Product Change Notice (PCN)

PCN Number: **PCN-0456190R-01**

Product(s) Affected: **PJ-072C-SMT-TR**

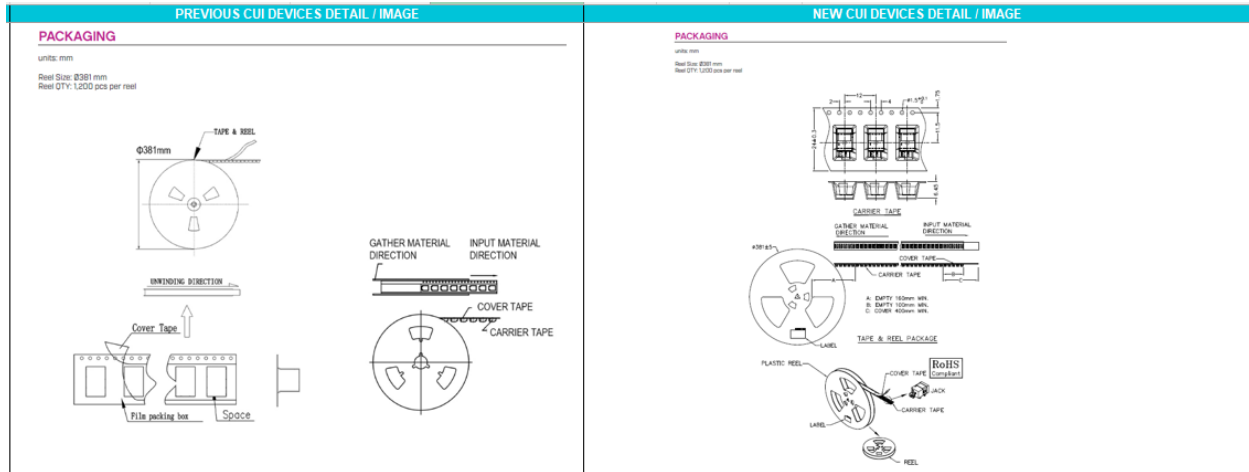
Description of Change: *New Factory Location. Product re-engineered for improved manufacturability and production yield. See image below for reference and check CUI Devices website for updated drawing. Cosmetic differences may be visible but will not affect the form fit and function of the product.*

PREVIOUS CUI DEVICES DETAIL / IMAGE	NEW CUI DEVICES DETAIL / IMAGE																																																
<table border="1"> <thead> <tr> <th>DESCRIPTION</th> <th>MATERIAL</th> <th>PLATING/COLOR</th> </tr> </thead> <tbody> <tr> <td>terminal 1</td> <td>copper alloy</td> <td>gold (contact area) tin (remaining portion)</td> </tr> <tr> <td>terminal 2</td> <td>copper alloy</td> <td>gold</td> </tr> <tr> <td>shield</td> <td>brass</td> <td>nickel</td> </tr> <tr> <td>housing</td> <td>PA10T (UL94V-0)</td> <td>black</td> </tr> </tbody> </table>	DESCRIPTION	MATERIAL	PLATING/COLOR	terminal 1	copper alloy	gold (contact area) tin (remaining portion)	terminal 2	copper alloy	gold	shield	brass	nickel	housing	PA10T (UL94V-0)	black	<table border="1"> <thead> <tr> <th>DESCRIPTION</th> <th>MATERIAL</th> <th>PLATING/COLOR</th> </tr> </thead> <tbody> <tr> <td>terminal 1</td> <td>copper alloy</td> <td>contact area: gold flash over nickel solder area: tin over nickel</td> </tr> <tr> <td>terminal 2</td> <td>copper alloy</td> <td>gold flash over nickel</td> </tr> <tr> <td>shield</td> <td>brass</td> <td>nickel</td> </tr> <tr> <td>housing</td> <td>PA10T (UL94V-0)</td> <td>black</td> </tr> </tbody> </table>	DESCRIPTION	MATERIAL	PLATING/COLOR	terminal 1	copper alloy	contact area: gold flash over nickel solder area: tin over nickel	terminal 2	copper alloy	gold flash over nickel	shield	brass	nickel	housing	PA10T (UL94V-0)	black

DESCRIPTION	MATERIAL	PLATING/COLOR																																															
terminal 1	copper alloy	gold (contact area) tin (remaining portion)																																															
terminal 2	copper alloy	gold																																															
shield	brass	nickel																																															
housing	PA10T (UL94V-0)	black																																															
DESCRIPTION	MATERIAL	PLATING/COLOR																																															
terminal 1	copper alloy	contact area: gold flash over nickel solder area: tin over nickel																																															
terminal 2	copper alloy	gold flash over nickel																																															
shield	brass	nickel																																															
housing	PA10T (UL94V-0)	black																																															
<p>SOLDERABILITY</p> <table border="1"> <thead> <tr> <th>parameter</th> <th>conditions/description</th> <th>min</th> <th>typ</th> <th>max</th> <th>units</th> </tr> </thead> <tbody> <tr> <td>rest storage</td> <td>10-30°C, <70% humidity</td> <td></td> <td></td> <td>40</td> <td>°C</td> </tr> <tr> <td>reflow soldering¹</td> <td>see reflow profile</td> <td>255</td> <td>260</td> <td>265</td> <td>°C</td> </tr> <tr> <td>drying conditions²</td> <td>parts in rest: bake at 110°C for 4 hours parts removed from rest: bake at 110°C for 4 hours</td> <td></td> <td></td> <td></td> <td></td> </tr> </tbody> </table> <p>Note: 1. CUI Devices recommends to solder within 72 hours from opening vacuum packaging at a temperature <30°C & relative humidity <60%. 2. When exceeding four (4) by <102 hours.</p>  <p>* Time 250 to Peak Temp: 8 Minutes Max. * Time with 90% of Actual Peak Temp: 30-40 Seconds</p>	parameter	conditions/description	min	typ	max	units	rest storage	10-30°C, <70% humidity			40	°C	reflow soldering ¹	see reflow profile	255	260	265	°C	drying conditions ²	parts in rest: bake at 110°C for 4 hours parts removed from rest: bake at 110°C for 4 hours					<p>SOLDERABILITY</p> <table border="1"> <thead> <tr> <th>parameter</th> <th>conditions/description</th> <th>min</th> <th>typ</th> <th>max</th> <th>units</th> </tr> </thead> <tbody> <tr> <td>rest storage</td> <td>at relative humidity <60%</td> <td></td> <td></td> <td>40</td> <td>°C</td> </tr> <tr> <td>reflow soldering¹</td> <td>see reflow profile</td> <td>255</td> <td>260</td> <td>265</td> <td>°C</td> </tr> <tr> <td>drying conditions²</td> <td>parts in rest: bake at 40°C <5°C for 72 hours parts removed from rest: bake at 40°C <5°C for 10 hours</td> <td></td> <td></td> <td></td> <td></td> </tr> </tbody> </table> <p>Note: 1. It is recommended to reflow solder within 72 hours from opening vacuum packaging at a temperature <30°C & relative humidity <60%. 2. When exceeding four (4) by <102 hours.</p> 	parameter	conditions/description	min	typ	max	units	rest storage	at relative humidity <60%			40	°C	reflow soldering ¹	see reflow profile	255	260	265	°C	drying conditions ²	parts in rest: bake at 40°C <5°C for 72 hours parts removed from rest: bake at 40°C <5°C for 10 hours

parameter	conditions/description	min	typ	max	units																																												
rest storage	10-30°C, <70% humidity			40	°C																																												
reflow soldering ¹	see reflow profile	255	260	265	°C																																												
drying conditions ²	parts in rest: bake at 110°C for 4 hours parts removed from rest: bake at 110°C for 4 hours																																																
parameter	conditions/description	min	typ	max	units																																												
rest storage	at relative humidity <60%			40	°C																																												
reflow soldering ¹	see reflow profile	255	260	265	°C																																												
drying conditions ²	parts in rest: bake at 40°C <5°C for 72 hours parts removed from rest: bake at 40°C <5°C for 10 hours
